Access Compliance Report

Public Rights-of-Way

Intersection ID: 13987	Main Street: KENHILL_DR	Cross Street: PARKMONT_DR	Location: SW
ADA ID: FCF20731FECF	Ramp Type: BlendTrans1	Initial Pass/Fail: Fail	Overall Compliance: No
		Severity Score: 10

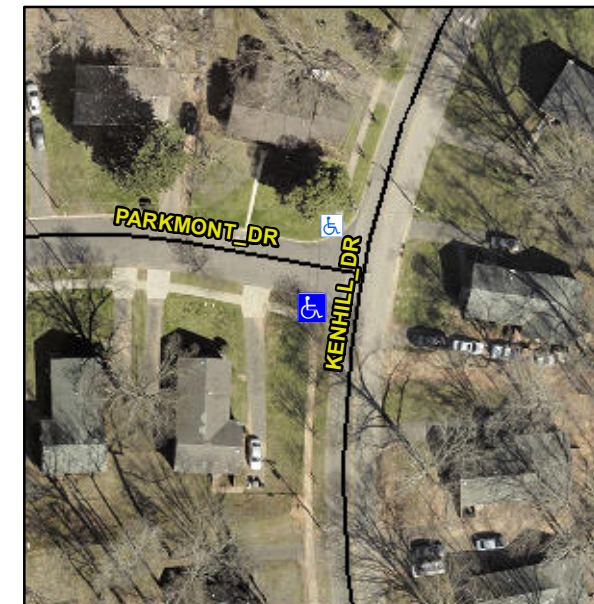
Not Found, R304.5.1, R304.5.3

Compliance	Description	Data	Compliance	Description	Data
N/A	Ramp Length (in)	73.0	Yes	BlendTrans Slope (%)	3.7
No	Ramp Width (in)	47.0	No	BlendTrans XSlope (%)	2.4
N/A	Flare Type LT	N/A	N/A	Flare Type RT	N/A
N/A	Flare Slope LT (%)	N/A	N/A	Flare Slope RT (%)	N/A
N/A	Flare Traversable LT?	N/A	N/A	Flare Traversable RT?	N/A
N/A	Landing Length (in)	N/A	N/A	DWS Provided?	N/A
N/A	Landing Width (in)	N/A	N/A	DWS Contrast?	N/A
N/A	Landing Slope (%)	N/A	N/A	DWS Length (in)	N/A
N/A	Landing X Slope (%)	N/A	N/A	DWS Full Width?	N/A
N/A	Landing Curb? (Y/N)	N/A	N/A	DWS Offset (in)	N/A
N/A	Shared Landing?	N/A			
N/A	Gutter Ponding?	N/A	N/A	Gutter Slope (%)	N/A
N/A	Gutter Lip Ht (in)	N/A	N/A	Gutter X Slope (%)	N/A
N/A	Painted X Walk1?	No	N/A	Painted X Walk2?	No
	X Walk 1 Direction	To E		X Walk 2 Direction	To N
	X Walk 1 Width (in)	N/A		X Walk 2 Width (in)	N/A
	X Walk 1 Slope (%)	4.2		X Walk 2 Slope (%)	1.4
	X Walk 1 X Slope (%)	1.6		X Walk 2 X Slope (%)	3.0

N/A	Ramp inside XWalk1?	N/A	N/A	Ramp inside XWalk2?	N/A
	Road Slope (%)	0.3		Clear Space?	N/A
	Road X Slope (%)	9.4	N/A	Clear Space to XWalk (in)	N/A
N/A	Any Obstructions?	N/A	N/A	Storm Grate/Utility Hazard?	N/A
	Obstruction Type			Storm Grate/Utility Type	
		N/A			N/A
			Yes	Surface Condition? (G/P)	Good
			No	Curb Slope (%)	14.6

Remove & Replace Curb Ramp With Two New Directional Ramps or Equivalent.
